Work Order ID 116126

Item Name: Stud Receiver, Lower

WORK ORDER NON-CONFORMANCE / UPDATE

14-3789

D4148-3 STUD RECEIVER LOWER

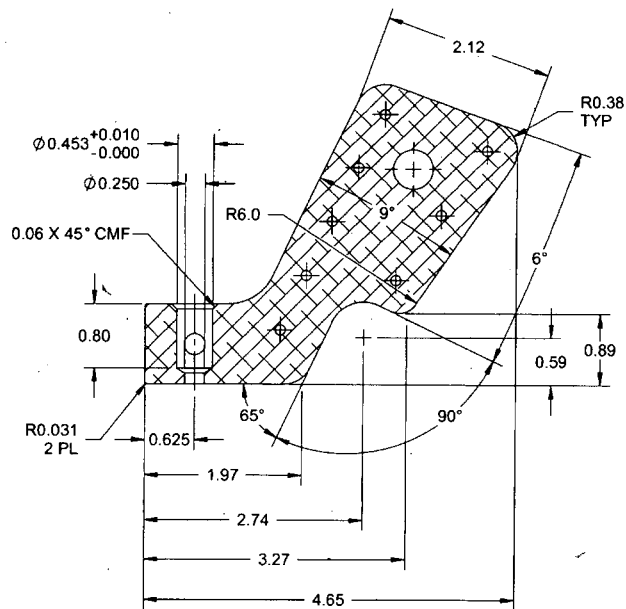
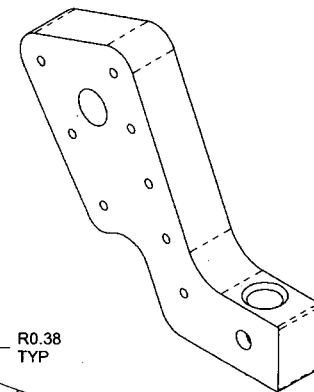
Root Cause	Date	Step	Qty	Description of work order update or non-conformance	Initial Chief Eng	Action Description	Sign & Date	Verification	D/S QC Inspector
Design	14.04.21	110	1	Ø.435 HOLE SHFT 4 IS 0.003" OFF CENTER	A.P. 14.04.21	• REDUCED CONTACT AREA, PER TP-D350-607-3, DRAG LOADS ARE LOW (MAX 393) DISTRIBUTED ACROSS 4 CONTACT POINTS • NO INSTALLATION/MISALIGNMENT ISSUE AS A RESULT OF DEVIATION. PART ACCEPTABLE AS IS	A.P. 14.04.21	27 9/59 14/4/21	14/4/21
Doc/Data									
Equip/Tooling									
Handling/Pre									
Material									
Operator									
Offset/Setup									
Process <input checked="" type="checkbox"/>				RC - position of part (location varies) operator setup error.					
Supplier									
Training									
Transport									
Unapproved
